E. BARRETT PRETTYMAN UNITED STATES COURTHOUSE ANNEX

Report to the General Services Administration

June 3, 1999

*South Elevation of the Rotunda
incorporating design changes in the base,
top floor windows and height of the roof.*

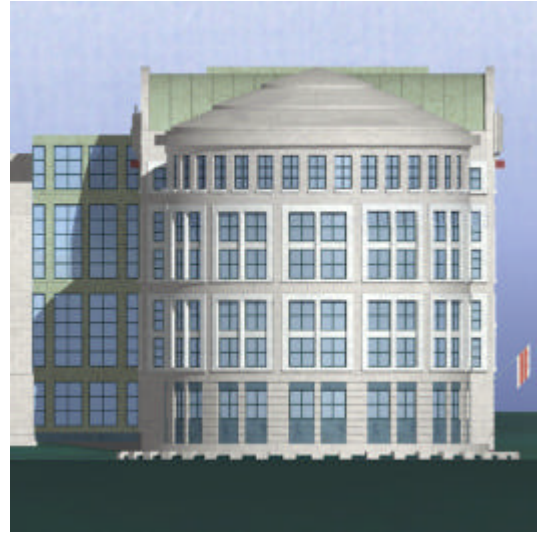
The Rotunda:

The revised design of the rotunda - specifically revision of the design of the base, the redesign of the windows on the top floor, and an increase in the height of the roof - has resulted in a scale, proportion and detailing that is felt to make a statement appropriate to the future landmark status of this element of the building.

- The columns at the base of the rotunda have been redesigned to reflect their size and spacing in the upper floors. This provides a more substantial base to the rotunda. The windows in the base have also been redesigned to better relate to the design and placement of the windows in the façade above. The design of the rotunda appears more harmonious.

- A greater number of windows have been incorporated in the design of the top floor of the rotunda. The location of these windows reflects the spacing of the columns in the lower floors. Distinctly different from the top floor windows of both the existing courthouse and those proposed for the top floor of the main annex, these windows help set the rotunda apart. This design is also felt to relieve the apparent weight of the dome and to reduce the overall perception of the mass of the rotunda.
- The stylized, stepped flat roof of the rotunda is compatible and does not compete with other roof forms in the area. The increased height of the roof and the varied roof pitch appears more comfortable in relation to the proportions of the rotunda. The increased height also enhances both the view from the street and distant views of the rotunda.
